STAFF REPORT
(One-Step Final Plat Deferred from 1/20/2000)

CASE NUMBER: S/D 00-04 -- MIDWEST HOUSING ADDITION

STAFF REPORT
(One-Step Final Plat)

CASE NUMBER: S/D 00-04 - MIDWEST HOUSING ADDITION

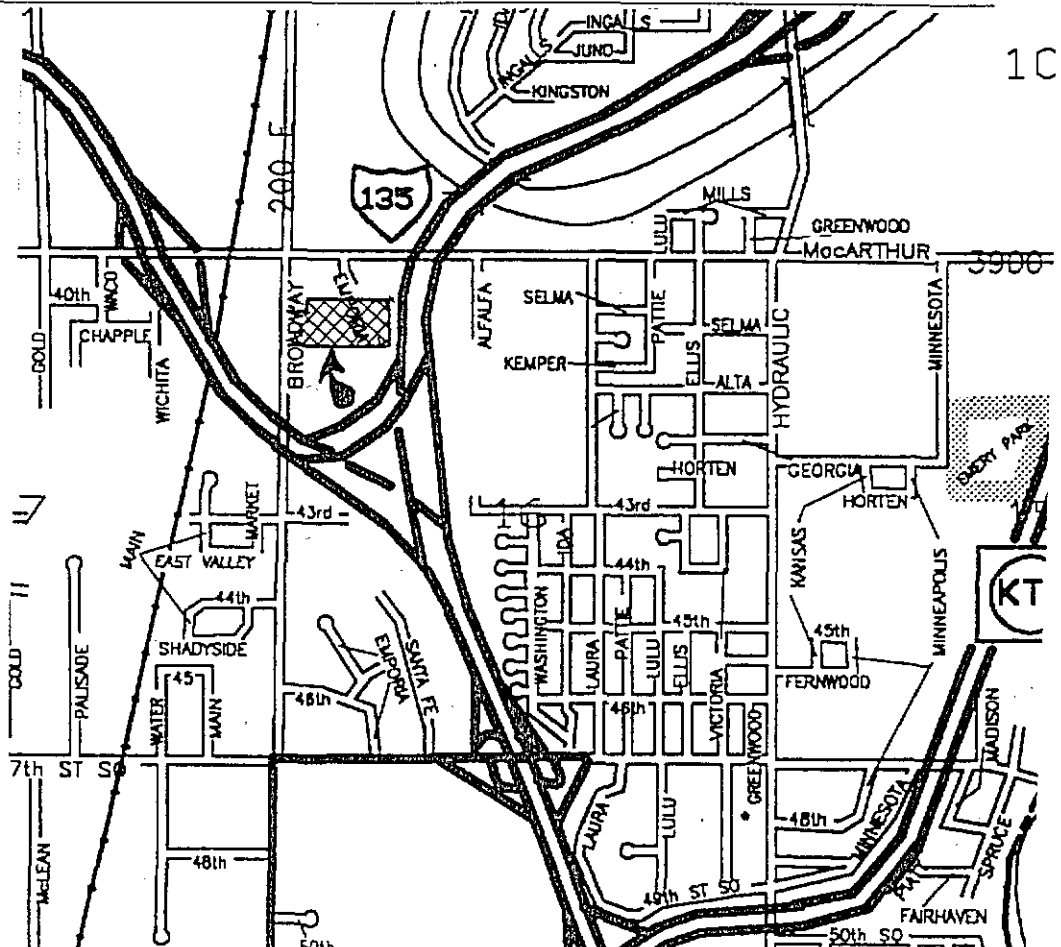
- C. City Engineering needs to comment on the status of the applicant's drainage plan.
- D. Traffic Engineering needs to comment on the access controls. The plat proposes one access opening in conformance with the CUP. The CUP also required a minimum distance of 300 feet between this opening and any opening located to the north or south; which should be denoted on the face of the plat. The applicant shall guarantee the closure of the driveway openings being located in areas of complete access control.

- H. In accordance with the CUP, a Cross-Lot Circulation Agreement shall be provided between this lot and the GC-zoned property to the south, which was part of the CUP.

- N. The applicant shall submit a copy of the instrument which establishes the Conoco pipeline easements on the property, which verifies that the easements shown are sufficient and that utilities may be located adjacent to and within the easements.

- O. The applicant's agent shall determine any setback requirements for the pipelines by researching the text of the pipeline agreements. If a setback from the pipeline easements is provided for in the pipeline easement agreements, it shall be indicated on the face of the plat.

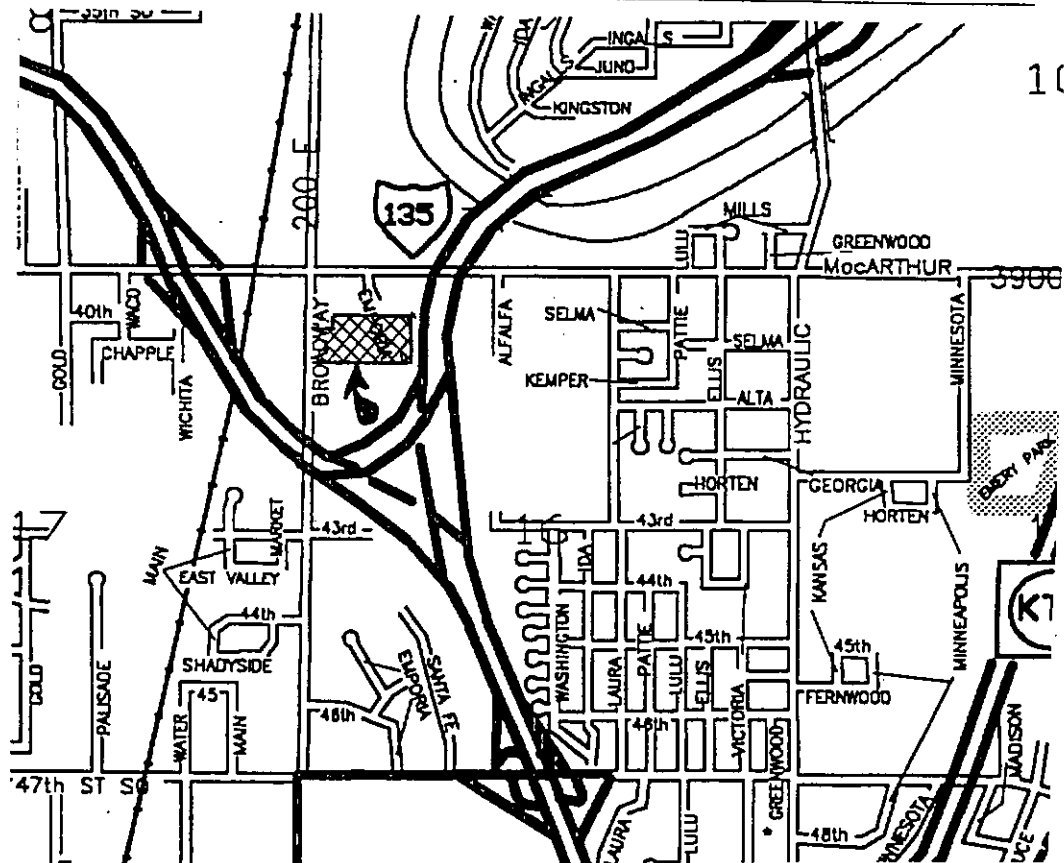
*drainage plan?
K dot approval?
SS flow to Block 2
Basement to Block 2
par. Emporia
Not develop lot, block?*

- C. City Engineering needs to comment on the status of the applicant's drainage plan.
- D. Traffic Engineering needs to comment on the access controls. The plat proposes two access openings for a single platted lot along Broadway. The CUP, however, only permitted one opening per lot, with a distance of 300 feet between the openings and any existing openings located to the north or south. These access controls shall be denoted on the face of the plat and referenced in the plat's text. The Applicant shall guarantee the closure of the driveway openings being located in areas of complete access control.

- H. A bold line should be denoted between the two lots.
- I. In accordance with the CUP, a cross-lot circulation agreement shall be provided between the lots and also with the GC-zoned property to the south.

- J. The plat's text shall note that the contingent dedication of right-of-way shall become effective upon the platting of the adjoining property to the south and that it will expire after 20 years.

- M. A temporary cul-de-sac would not appear to be needed due to the continuation of Emporia if development to the south occurs.
